RE: Approval of the schematic design of Parcel E-2 of the Pier 70 Mixed Use Development

Memo to the Planning Director

Date: February 19, 2019
Case No.: **2014-001272PHA**
Project: **Pier 70 Mixed Use Project Building E2**
Zoning: P70-MU (Pier 70 Mixed Use)
Pier 70 Special Use District
40-X & 65-X Height and Bulk Districts
Block/Lot: 4052/001
Project Sponsor: Brookfield Properties
875 Howard Street Suite 330
San Francisco, CA 94103
Staff Contact: Michael Christensen – (415) 575-8742
Michael.Christensen@sfgov.org
David Beaupre – (415) 274-0539
David.beaupre@sfport.com
Recommendation: **Approve the Schematic Design**

PIER 70-E2 PLANNING RESUBMITTAL

A0.1.7a

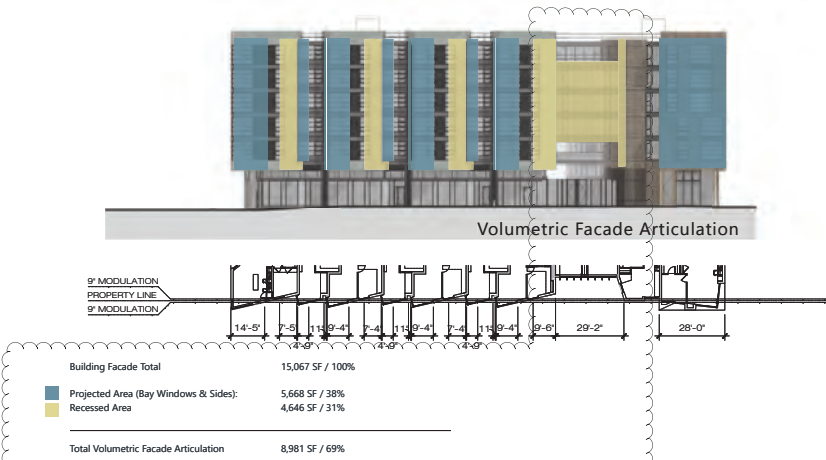
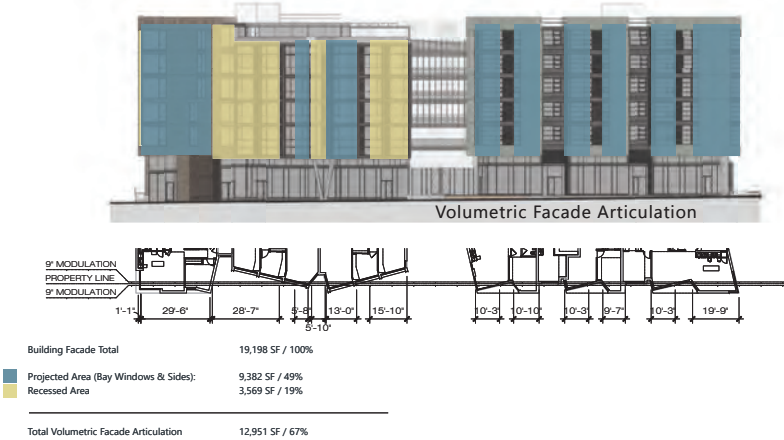
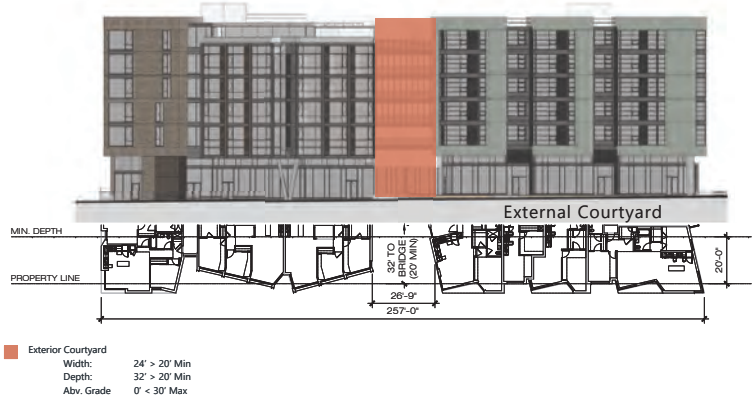
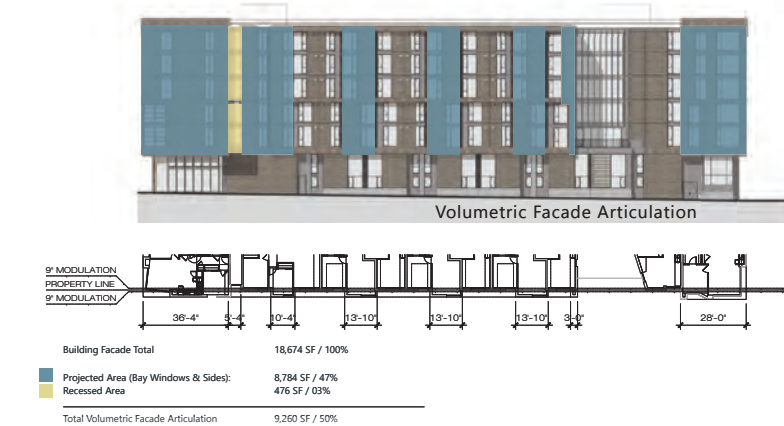
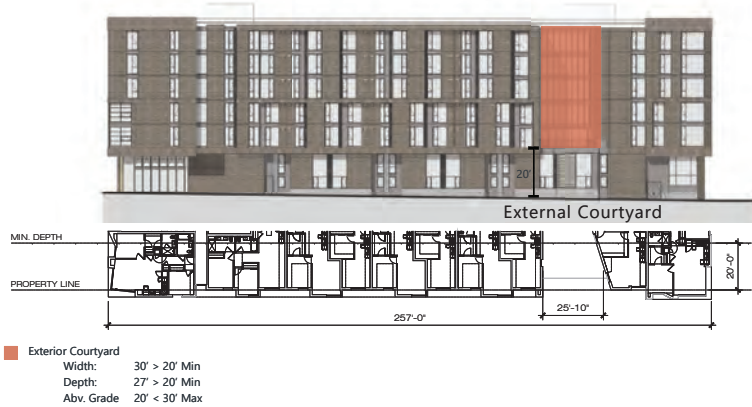
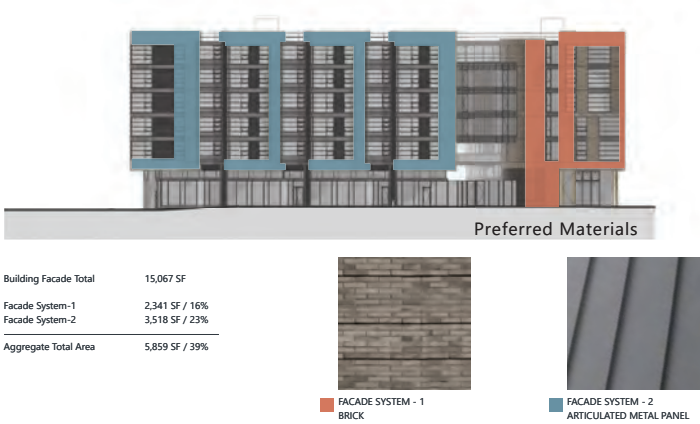
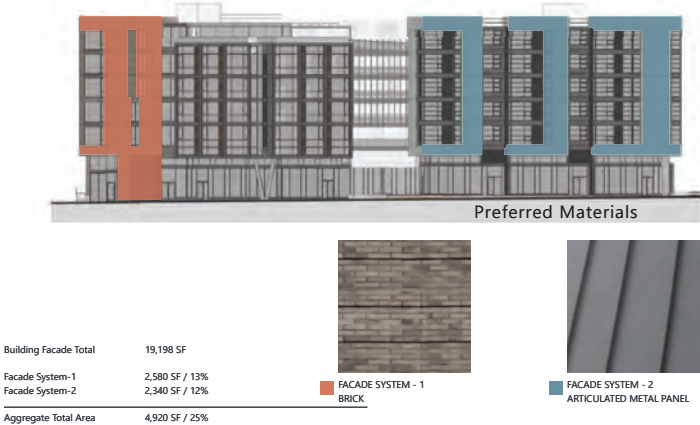
S6.18.7	Massing: Qualifying Strategies. To qualify for a massing credit, a façade shall comply with the minimum dimensions outlined in Table 6.18.3.	Yes	See sheet A0.1.7a for compliance diagrams.
